**To: The EIS Coordinator (Baralaba South Project), The Chief Executive, Queensland
Department of Environment, Science and Innovation
RE: Baralaba South Project – Environmental Impact Statement**

This submission examines the economic rationale for the proposed Baralaba South project under Mining Lease Application (MLA) 700057 and reviews the cost benefit analysis (CBA) submitted in the Baralaba South EIS. The submission finds critical failures in the stated project rationale and significant problems with the assumptions made in the CBA submitted in the EIS. These are summarised below and detailed in this document.

Figure 3: International Energy Agency – Market Prices for Different types of coal, 2016-2022

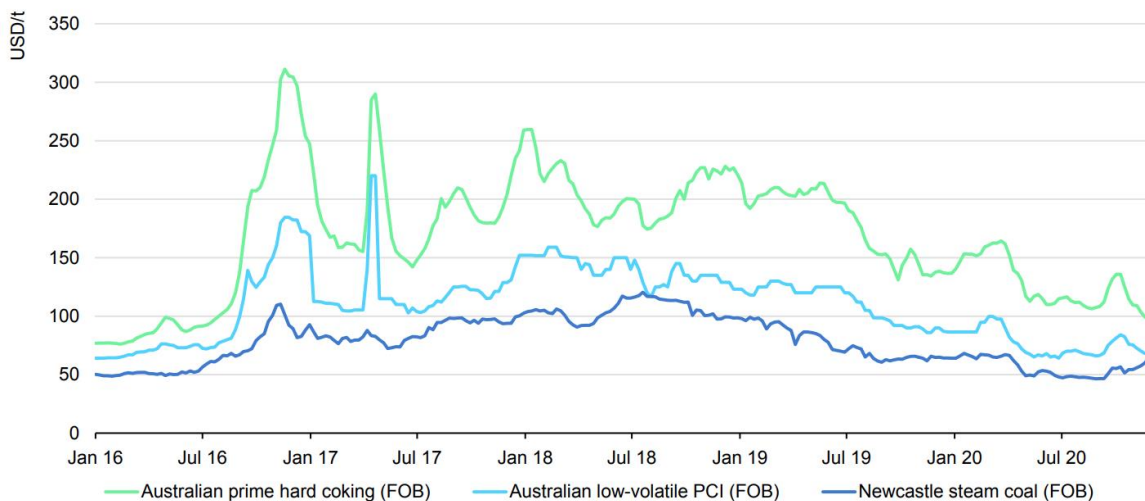
If PCI coal sale prices returned to 2020 levels before the Baralaba South project begins operations the proponents could hope to achieve somewhere between USD64 per tonne to USD100 per tonne. This is significantly less than the average PCI coal price assumption of USD180 per tonne used in the CBA.

Figure 4. Estimated NPV¹ based on PCI coal price adjustments.

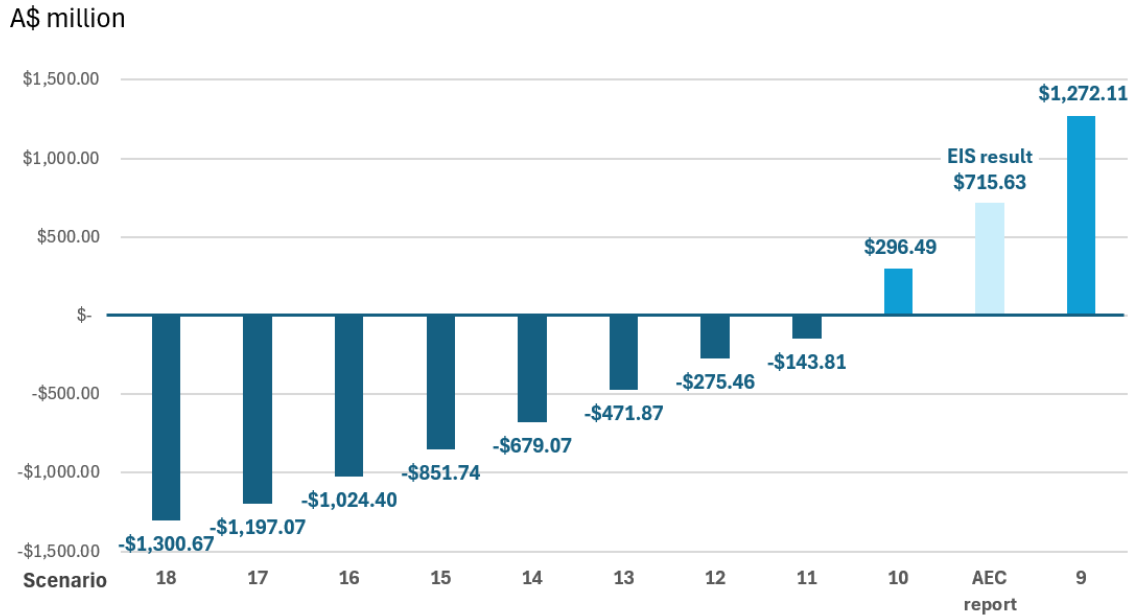
IEEFA has reviewed the estimated revenue from operations under different pricing scenarios and finds the project is highly vulnerable to lower PCI coal prices. IEEFA has examined how declining PCI coal prices could impact on the project’s financial viability assuming all other inputs remain equal and found that a negative NPV is generated for the project in almost all scenarios, as shown on Figure 4. This is based on the low-end KPMG forecast submitted in the EIS as well as historical PCI coal prices achieved prior to the period of coal price spikes experienced through 2021 and 2022.

Figure 7. Estimated NPV¹ based on unit cost adjustments.

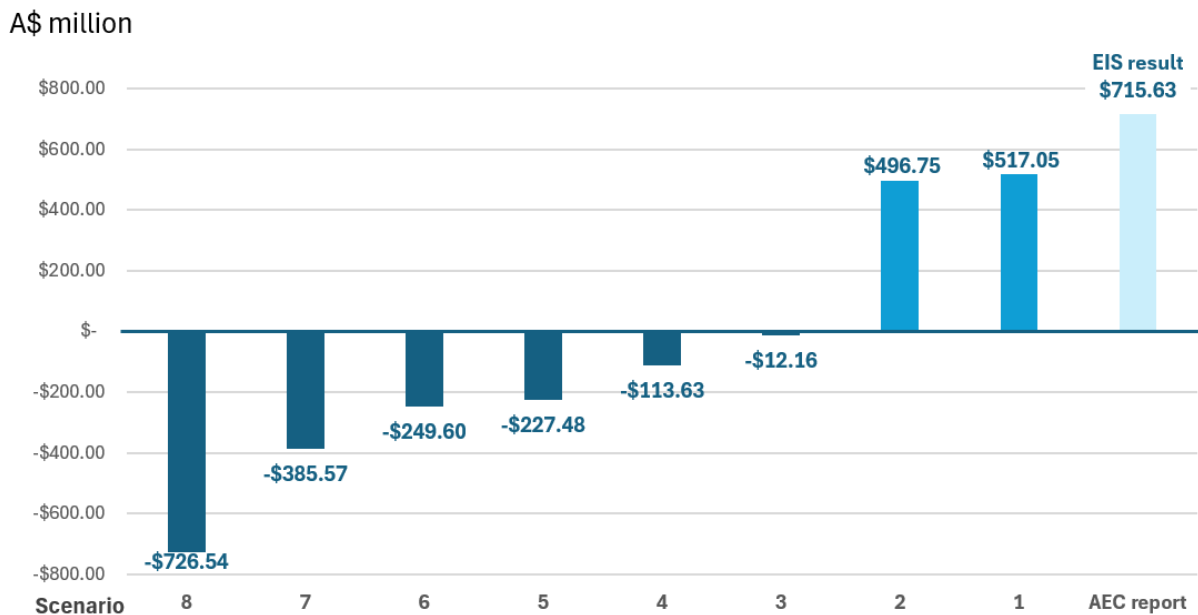
The Bluff coal mine unit costs have been used as a worst-case scenario in an analysis of the submitted CBA. Swapping out the unit cost assumptions made by the Baralaba South proponents with the actual unit costs of the Bluff mine during H2 FY2023 would mean that the proposed Baralaba South Project would generate a negative NPV of **-AUD725.45 million and a benefit-cost ratio (BCR) of 0.82 (Scenario 8 on Figure 7). This assumes all other cost and benefit**

Figure 8. Estimated NPV¹ based on adjusted scenarios

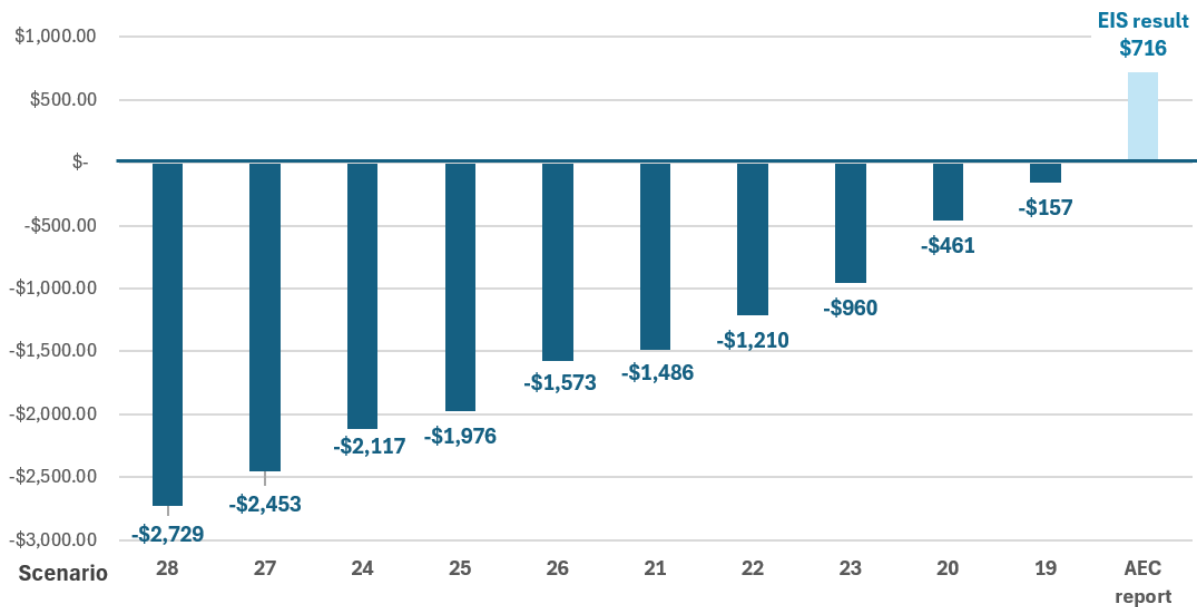
Sections 2.1 and 2.2 have highlighted the volatility of PCI coal prices and suggest that long-term demand for PCI coal will be weaker. Accordingly, it is possible that prices will subdue to pre-2021 levels. Section 2.2 outlines the industry trends of rising operating costs, indicating that the operational costs used in the CBA submitted in the EIS are likely to be underestimating the actual unit costs that the project would incur.

Figures 4 and 7 make variations to the PCI coal prices achieved and the unit costs per product coal assuming all other factors remain equal. It is unlikely that either PCI coal prices or operating costs increase or decrease in isolation; therefore it is warranted to investigate how changes in both factors would impact on the economic viability of the project. Figure 7 below runs alternate scenarios based on changes to both operating costs and achieved PCI coal prices. The findings indicate that the NPV of the project is likely to be negative, with a benefit-cost ratio of less than 1, in all scenarios. Additionally, the estimated revenue from operations generated by these scenarios is consistently less than the AUD3.1 billion published in the EIS (in present value terms using a 7% discount rate).⁵⁴

Figure 9. PV¹ estimation of royalties paid to Queensland government under different scenarios.

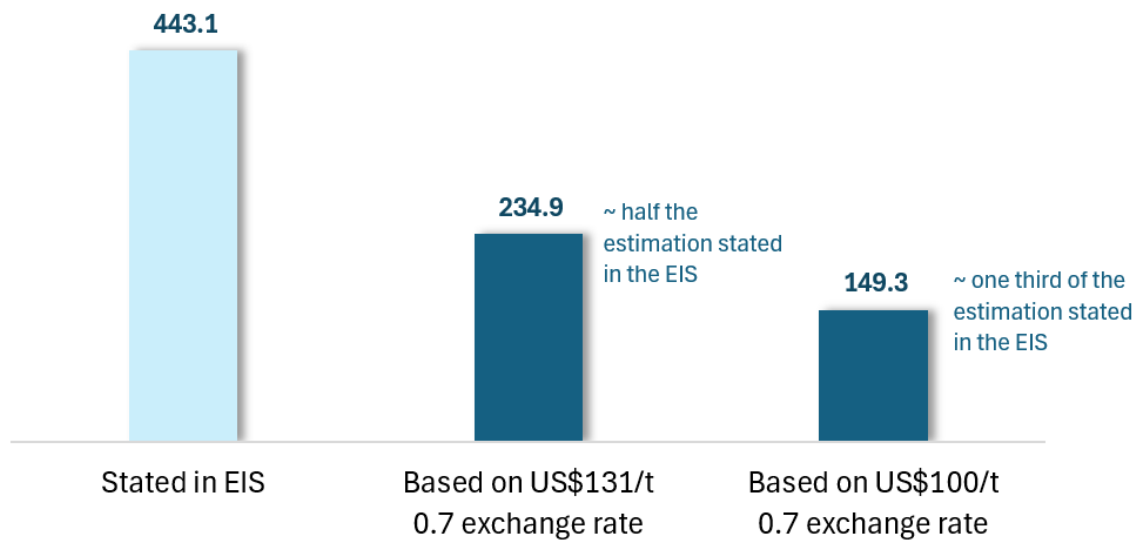
Queensland government.⁵⁵ IEEFA’s analysis finds that, even using the KPMG low estimate price forecast for PCI coal of USD131 per tonne and a 0.7 exchange rate, the PV of the royalties paid to the Queensland government would be almost half the **AUD443.1 million** figure stated in the EIS at **AUD234.9 million**.
